### Findings, Conclusions and Decision Public Works Variance EN-22-0049

Site: The Reserve Typical Minor Arterial Roadway Section Variance  
Parcel No. 0222323134

**RE: The Reserve — CPH Project No. 0228-21-001**  
**Request for Public Works Standards Variance EN-22-0049**  
**Roadway Section Minor Arterial Residential**

FIGURE 1

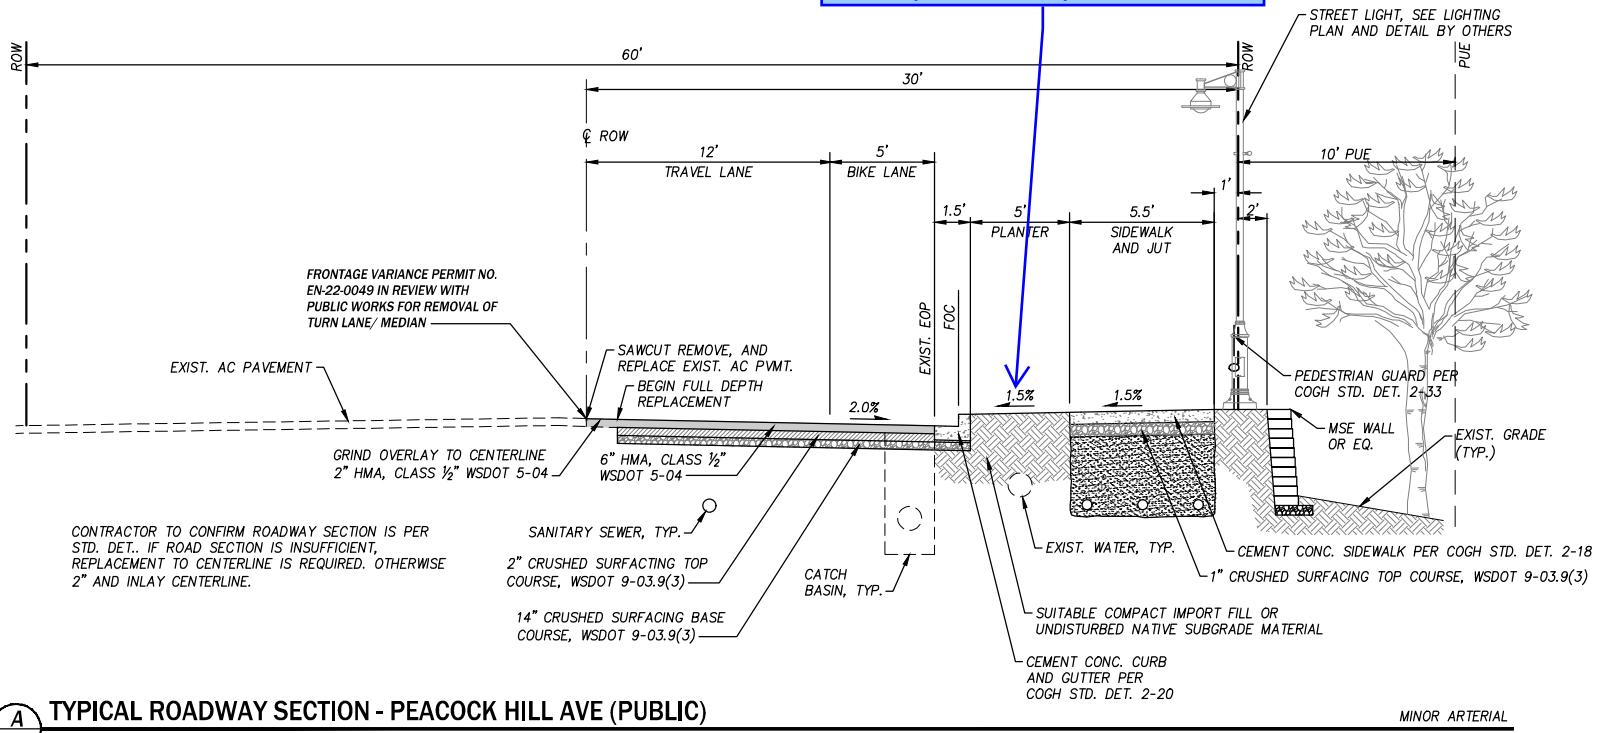
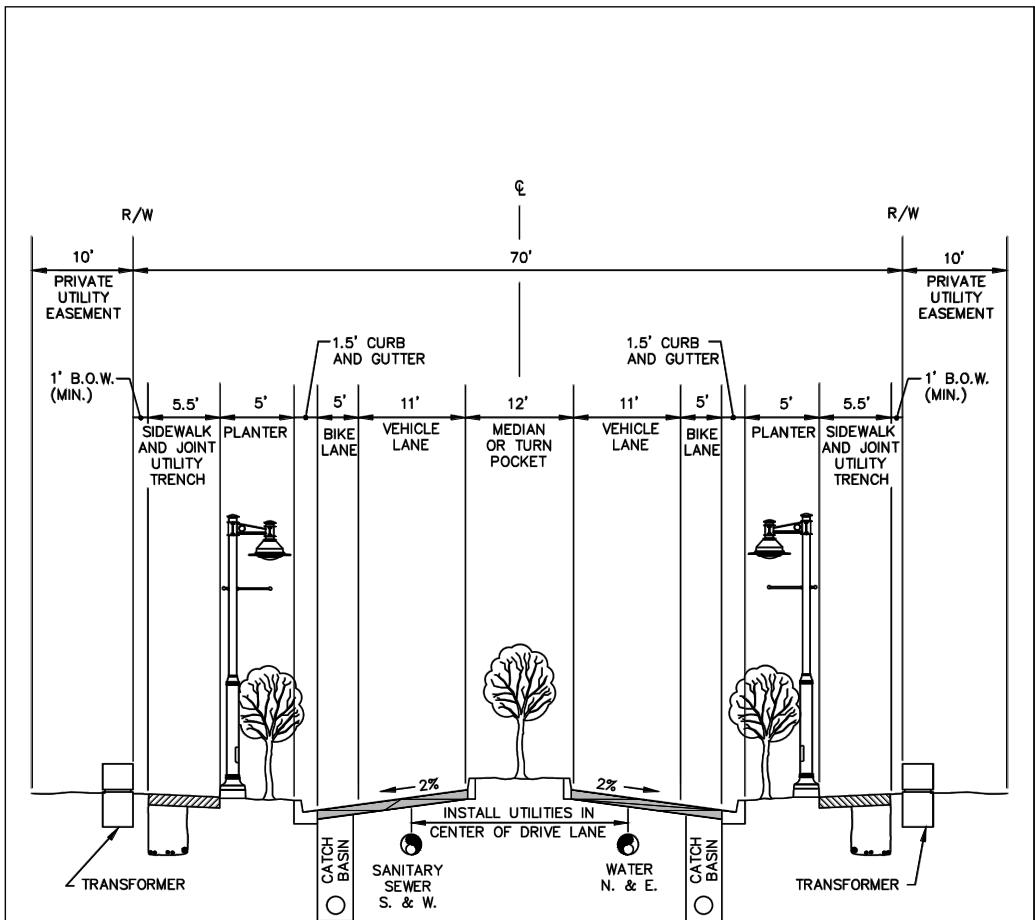
The 2018 City of Gig Harbor Public Works Standards (PWS) Section 2B, Figure 2.1 specifies minimum requirements for minor arterial residential roads. This includes reference to Standard Detail No. 2-03 (see Figure 1). This standard specifies half street improvements that include a 6-foot (half) median or turn pocket, 11-foot travel lane, 5-foot bike lane, 1.5-foot curb and gutter, 5-foot planter, 5.5-foot sidewalk, and minimum 1-foot setback to the public right-of-way (ROW). The requested variance would remove 5 feet of the 6-foot median or turn pocket area and result in half-street improvement with a 12-foot travel lane, 5-foot bike lane, 1.5-foot curb and gutter, 5-foot planter, 5.5-foot sidewalk and 1-foot clear area to the new ROW (see enclosed Figure 1). The turn lane is not a necessary road element for Peacock Hill Avenue based on the project traffic analysis. Omitting it will reduce the grading impacts along the east ROW and increase the number of trees preserved within landscape buffers, and it aids in minimizing the amount of fill required which in-turn reduces the overall earthwork imbalance for the project.

Applicant is not requesting a variance from illumination location. Current PW Standards call for illumination in the planter strip.

**FIGURE 5**  
**CROSSWALK AND**  
**RAMP DETAIL**

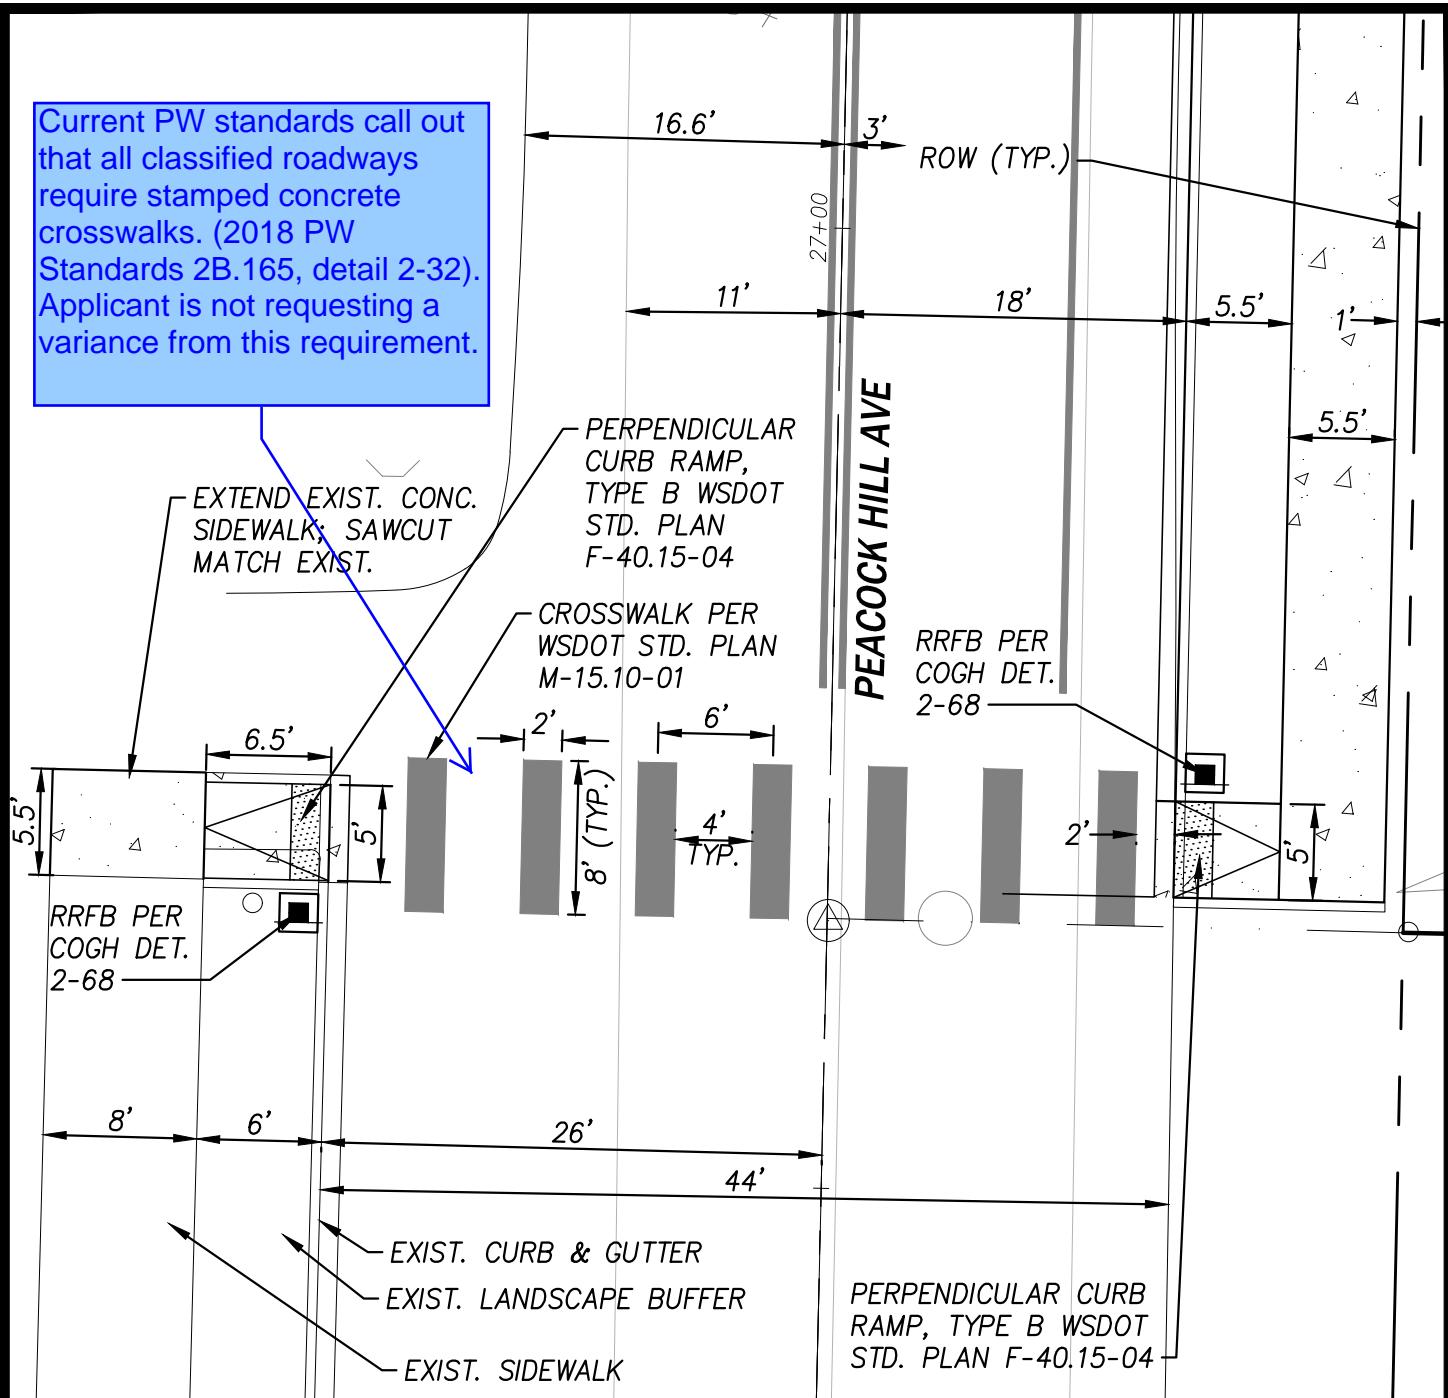
As a compensating benefit to the city and public, and based on the recommendation by COGH City Engineer, future capital improvements identified in the City's 6-year COGH Transportation Improvement Plan, and available sight distance; the project proposes to install a crosswalk with rectangular rapid flashing beacon (RRFB) at the southwest corner of The Reserve frontage. This crosswalk, RRFB, and associated ADA curb ramps will connect the project's sidewalk/frontage improvements with the nearest existing public sidewalk facilities on the west side of Peacock Hill Avenue. The proposed crossing location was selected based on a collaborative discussion of alternatives with the City Engineer. A review of the safety of the proposed project is provided in section 5 of this letter and included three figures illustrating entering sight distance from the closest intersections north and south of the proposed crosswalk as well as stopping sight distance for the crosswalk along Peacock Hill Avenue. See section 5 for a detailed review and reference to the above-mentioned figures.

Current PW standards call out that all classified roadways require stamped concrete crosswalks. (2018 PW Standards 2B.165, detail 2-32). Applicant is not requesting a variance from this requirement.

**FIGURE 6**  
**ROAD A SIGHT DISTANCE**

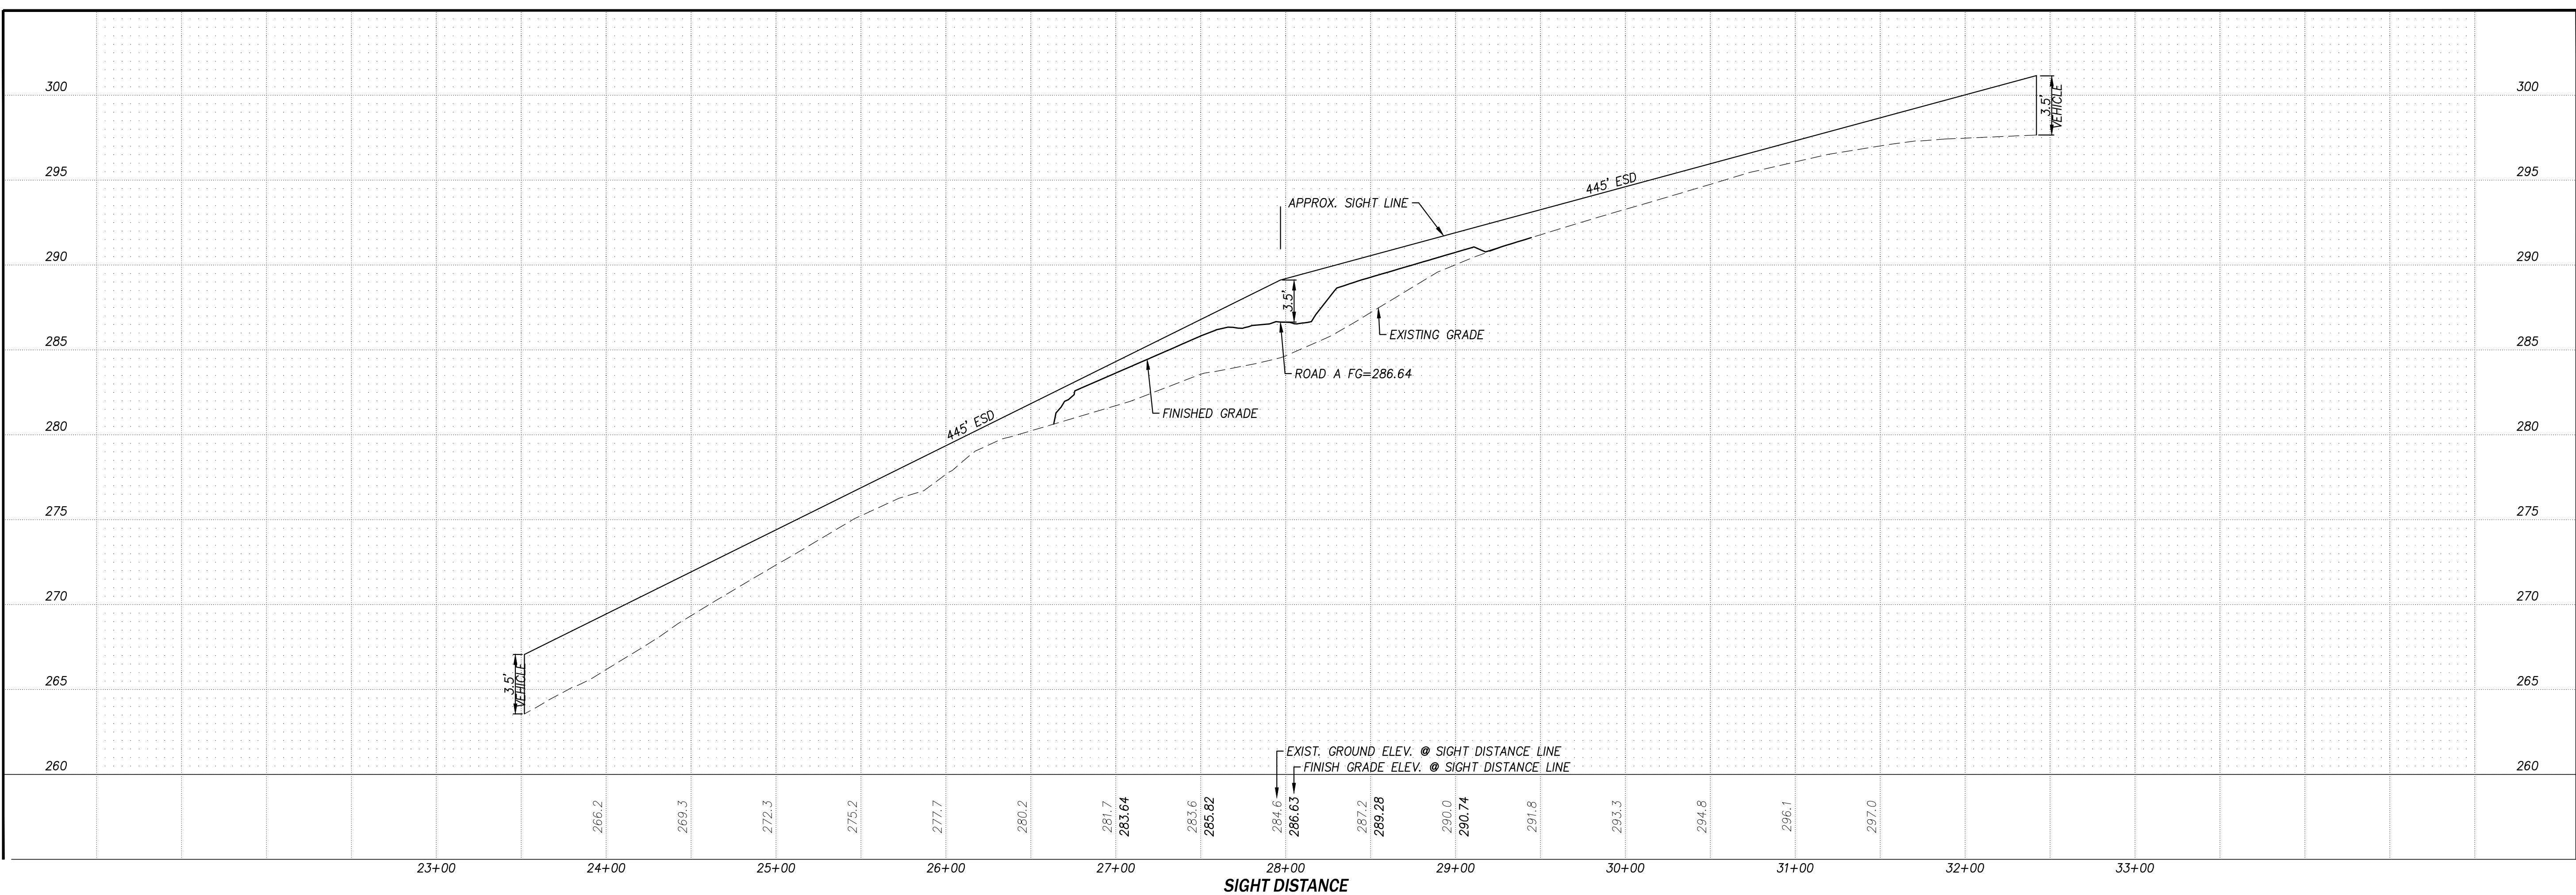
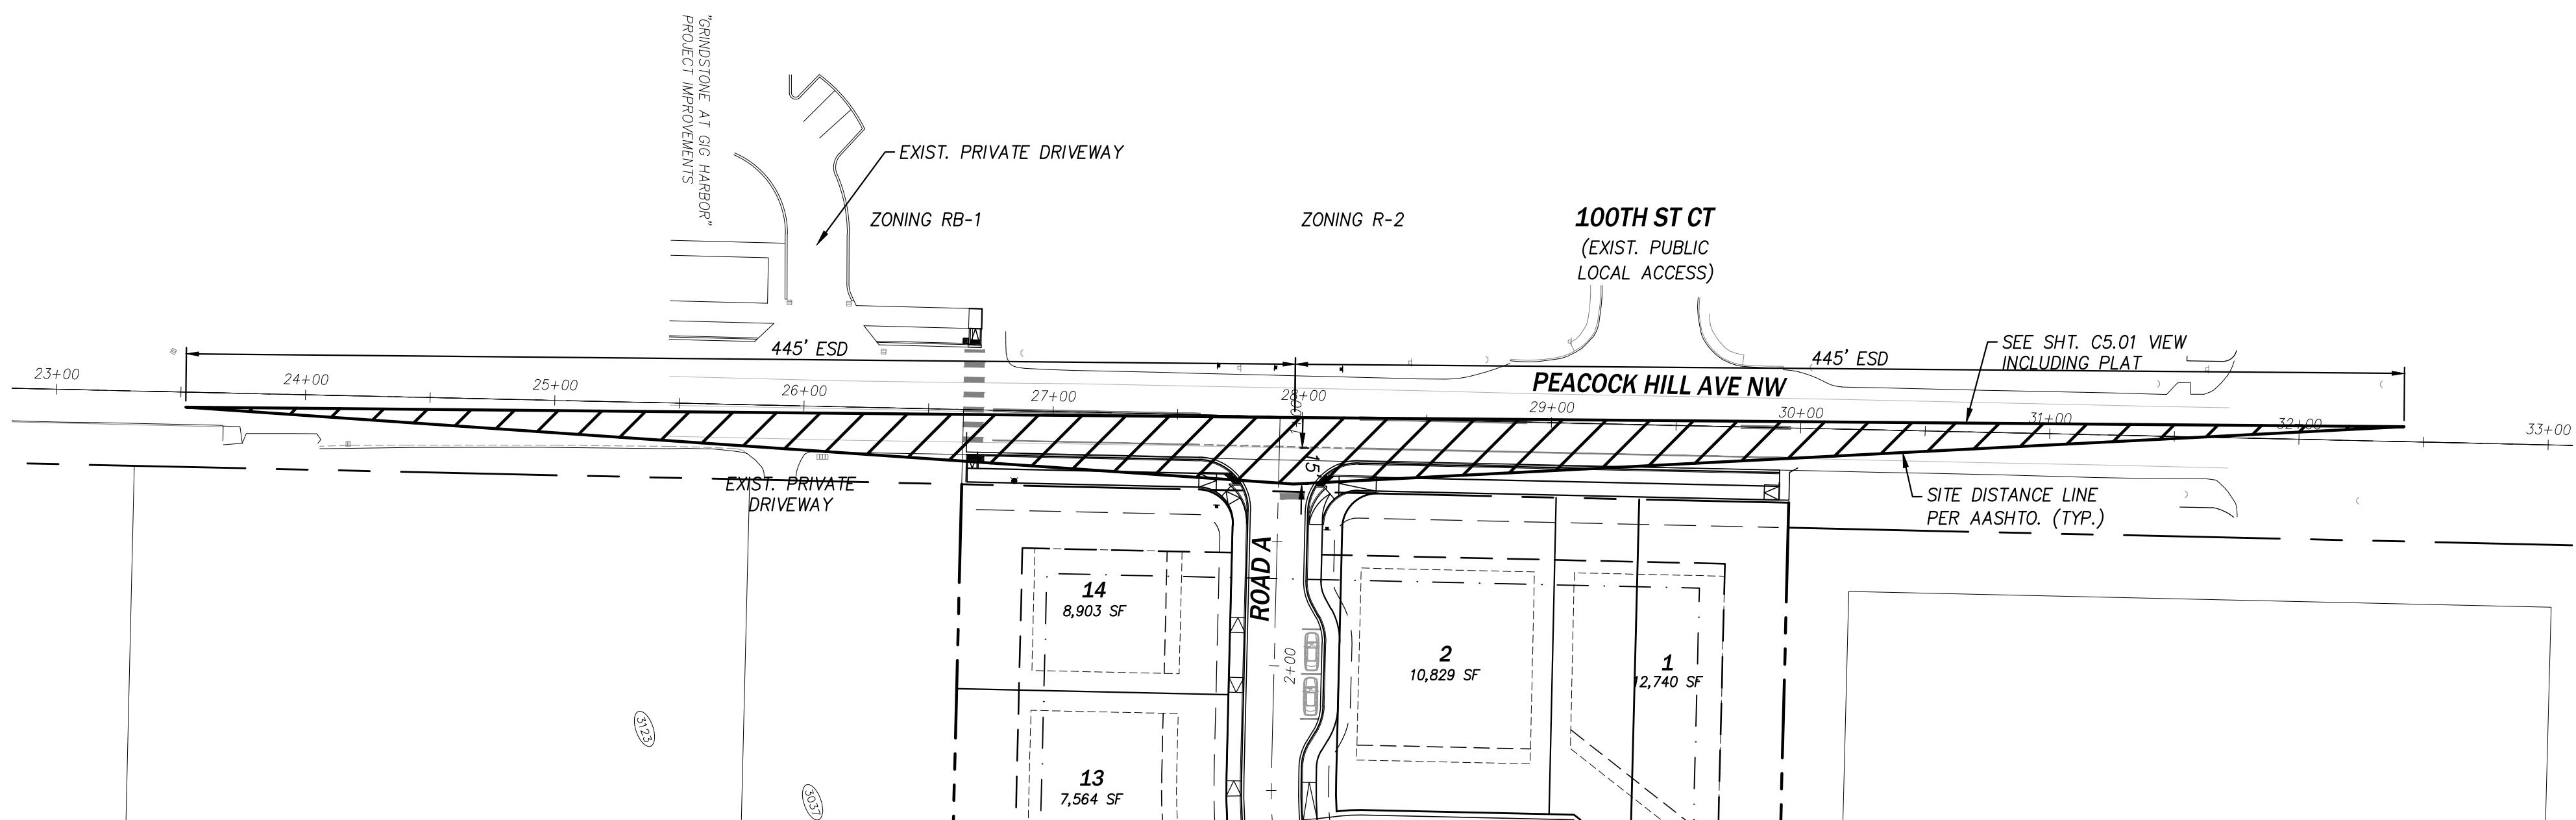
A review of the safety related to installing a crosswalk with RRFB is also provided. To assess the safety, Entering Sight Distance (ESD) from the closest intersection north and south of the proposed crosswalk location was established. The attached Figure 6, *Road A and Peacock Hill Sight Distance* shows the ESD from the closest intersection north of the crosswalk. The ESD is determined based on AASHTO, *A Policy on Geometric Design for Highways and Streets, 2018, 7<sup>th</sup> Edition* (AASHTO) requirements, specifically, Section 9.5.2.3, Table 9-7, for a left turn from stop, Peacock Hill Avenue. requires an ESD of 445 feet based on a 40 mph design speed, is calculated as the minimum necessary for a vehicle to make a safe decision when turning onto Peacock Hill Avenue. Figure 7 illustrates that the available ESD for the 99<sup>th</sup> Street and Peacock Hill Avenue intersection exceeds the 445 feet minimum.
